**CITY OF SEATTLE  
ANALYSIS AND RECOMMENDATION OF THE DIRECTOR  
OF THE DEPARTMENT OF PLANNING AND DEVELOPMENT**

**Application Number(s):** 2403714 and 2402617  
**Applicant Name:** Jennifer Grant for Lexington Fine Homes  
**Address of Proposal:** 3901 West Dravus Street  
**Clerk File Number:** 306749

**SUMMARY OF PROPOSED ACTION**

Figure 1 Setback Comparison Along W Dravus St

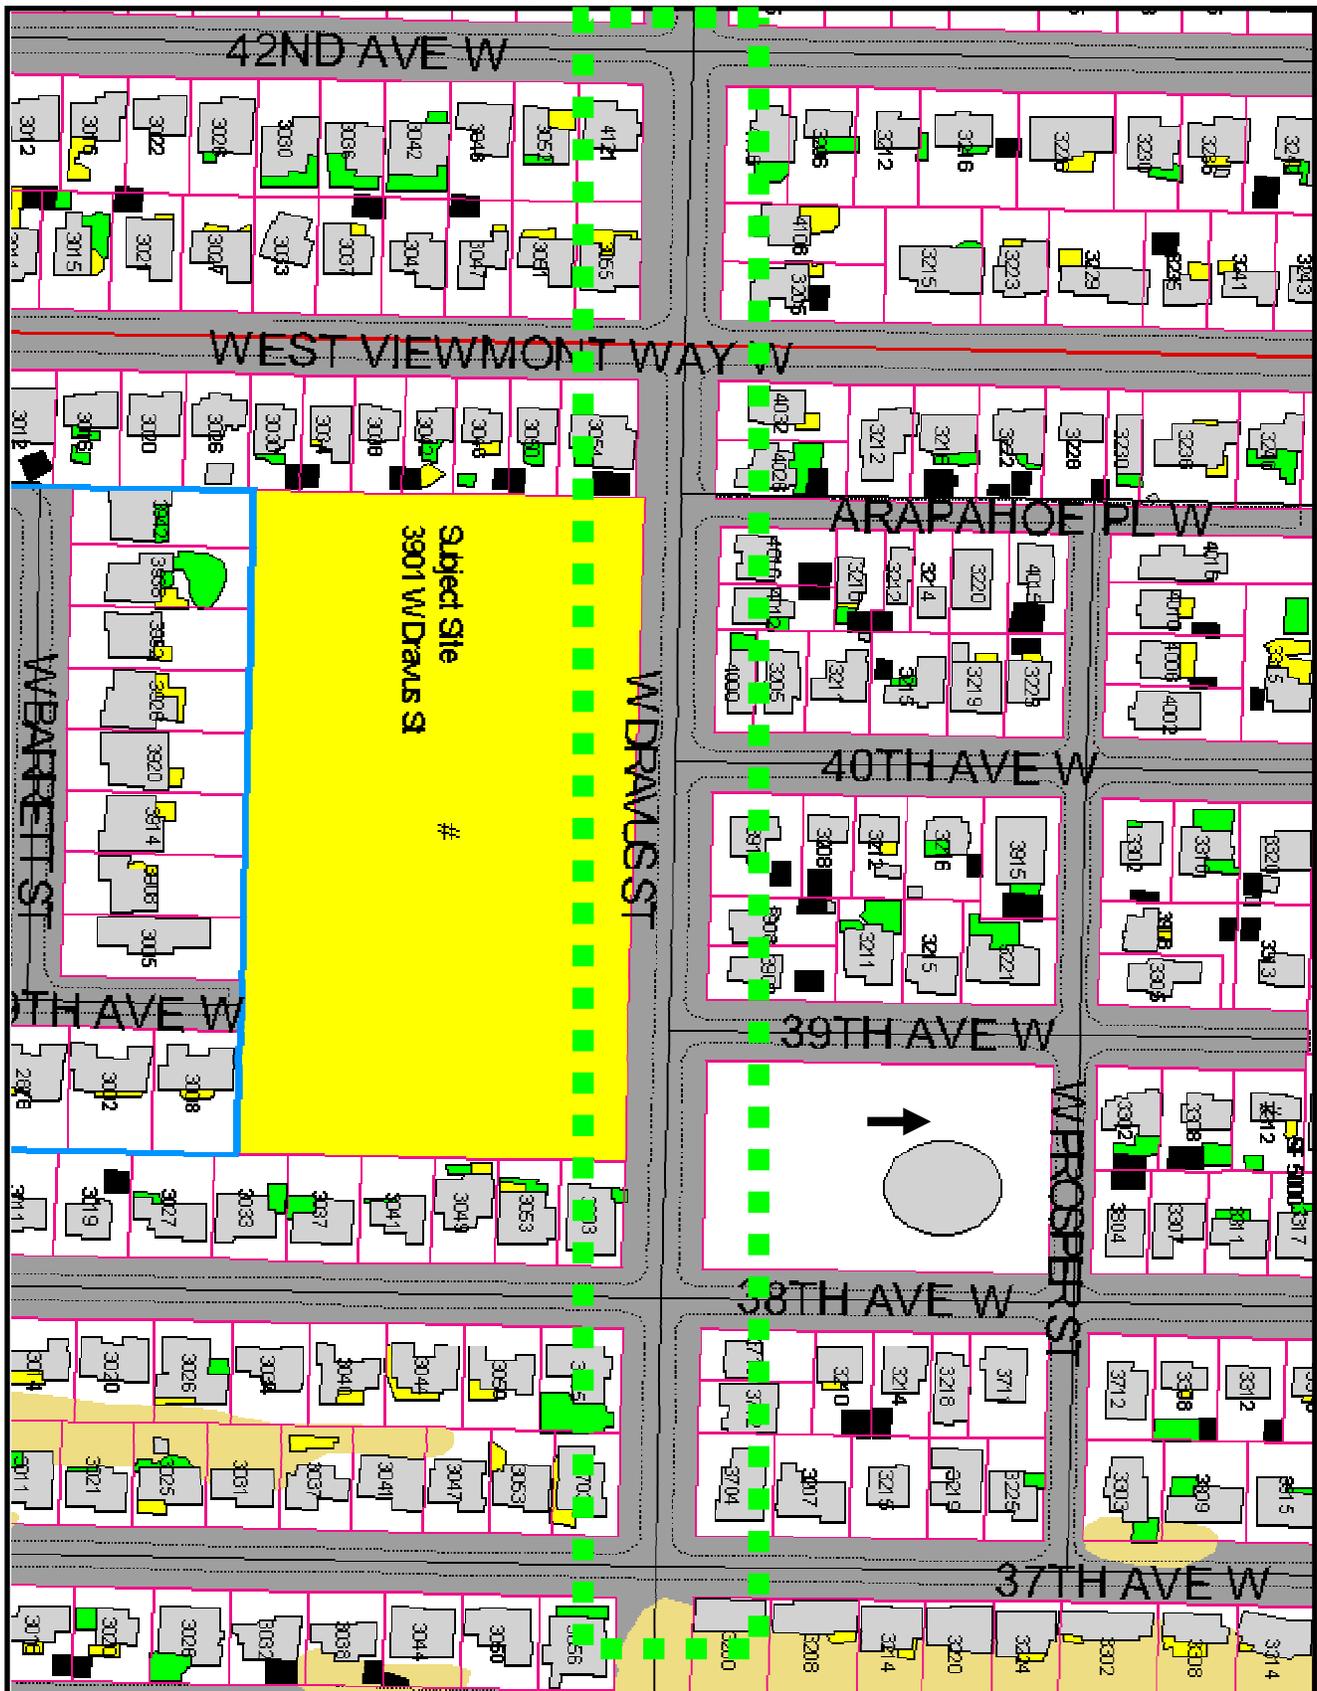
A review of the site context is appropriate to analyze and maintain a compatible scale and design with the surrounding community, pursuant to language in criterion E-7 below. On the north side of W Dravus St from 42<sup>nd</sup> Ave W easterly to 37<sup>th</sup> Ave W, a mix of side and front setbacks are found. The setback patterns are not consistent for properties that abut the north side of W Dravus St. Some lots are oriented to face east/west to the corresponding Avenue, with side lot lines abutting W Dravus St. Other lots are oriented to face south towards W. Dravus St, with front lot lines abutting W. Dravus St. As shown in Table 3 below, lots north of and abutting W Dravus St from 42<sup>nd</sup> Ave W to 37<sup>th</sup> Ave W have varying setbacks from approximately thirteen (13) to twenty-four (24) feet<sup>\*</sup>, with an average of approximately 19.4' (see table 3 below and figure 1 at the end of this document).

On the south side of W Dravus St. from 42<sup>nd</sup> Ave W easterly to 37<sup>th</sup> Ave W, all the lots that have street frontage have side lot lines that abut W. Dravus St, no front lot lines. The side lot line pattern facing W Dravus St is consistent along the south side of W Dravus St between 42<sup>nd</sup> Ave W and 37<sup>th</sup> Ave W. As shown below in Table 2, the setbacks south of W Dravus St for lots vary from approximately zero (0) to fourteen (14) feet<sup>\*</sup>, with an average of approximately 8.4' (see table 2 below and figure 1 at the end of this document).

For lots 22 – 30, the applicant proposes a fifteen (15) foot setback. Lots are proposed to be oriented with front yards facing W Dravus St. As stated above, the established pattern along the south side of W Dravus St is dominated by side setbacks (yards). Since the subject lots (22-30) are proposed to provide their front yards facing W. Dravus St where the predominant pattern is side setbacks, further analysis is appropriate. Table 3 below summarizes the approximate front setbacks\* for structures that provide their front yards on the north side of W. Dravus St from 42<sup>nd</sup> Ave W easterly to 37<sup>th</sup> Ave W.

In concert with the above information, the appropriate setback to provide a compatible scale and design with the surrounding community must take into consideration, along with the north structure setbacks, the predominance of side setbacks provided along the south side of W. Dravus St. As stated above, the setbacks for the structures on the south side of W Dravus St are between zero (0) and fourteen (14) feet with an average of 8.4'. If the prescribed 20' were required along W Dravus St it would create a pattern of setbacks not consistent with the surrounding community.

1. Lots 1-6 must provide ten (10) foot front yards (setbacks) from 39<sup>th</sup> Ave W.
2. Lots 31-39 must provide ten (10) foot internal front yards (setback) from the abutting sidewalk.
3. Lot 15 must be shown to meet required CHPD yards.
4. A tree protection plan shall be provided for review and proposal to the Land Use Planner according to the analysis above (see subsection F of the ACU analysis). The plan should retain all existing landscaping to the greatest extent possible.
